SUBJECT: COMANCHE PEAK NUCLEAR POWER PLANT, UNITS 3 AND 4
DOCKET NUMBERS 52-034 AND 52-035
RESPONSES TO REQUESTS FOR ADDITIONAL INFORMATION
NO. 2757, 2819, 2836, 2837, AND 3592

Response to Request for Additional Information No. 2757 (CP RAI #67)

Response to Request for Additional Information No. 2819 (CP RAI #66)

Response to Request for Additional Information No. 2836 (CP RAI #68)

Figure 13.1-205 CPNPP Units 3 and 4 Plant Staff Hiring and Training Plan

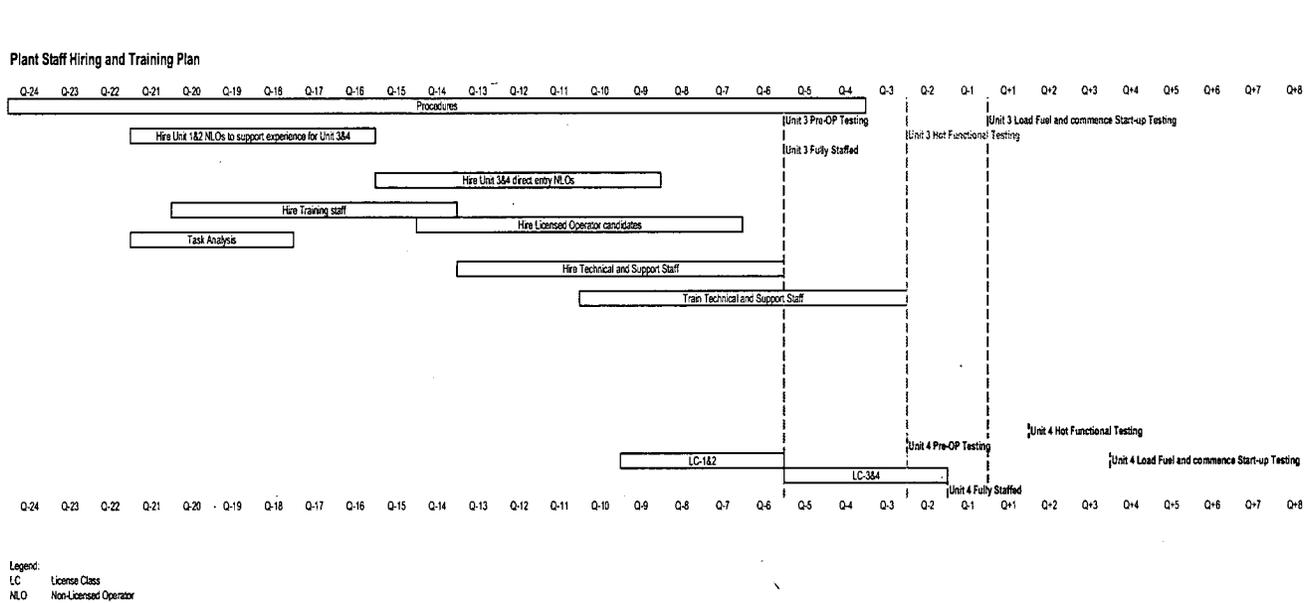
Standard Review Plan Section 13.1.1, "Management and Technical Support Organization," section I.1.B.ii states that the applicant should provide a description of the plan for the development and implementation of the applicant's staff recruiting and training programs. FSAR section 13.1 does not appear to include a description of the plan to develop the staff recruiting and training programs.

The plant staff training program is provided in Section 13.2. These plans will be substantially accomplished before preoperational testing begins as shown in new FSAR Figure 13.1-205, "CPNPP Units 3 and 4 Plant Staff Hiring and Training Schedule." Reactor operator (RO) and senior reactor

FSAR Figure 13.1-205 is based on information of NEI 06-13A, "Template for an Industry Training Program Description." This template has been developed by the New Plant Training Task Force, which is the subject of an on-going discussion under the operator readiness task force meetings. Figure 13.1-205 shows the relative positions of hiring and training milestones (i.e., first license class, etc.) for the various types of personnel (i.e., licensed operators, non-licensed operators, technical and support personnel). The staffing plan for CPNPP Units 3 and 4 nuclear personnel, based on ANSI/ANS3.1-1993 functional positions, is provided in FSAR Table 13.1-201.
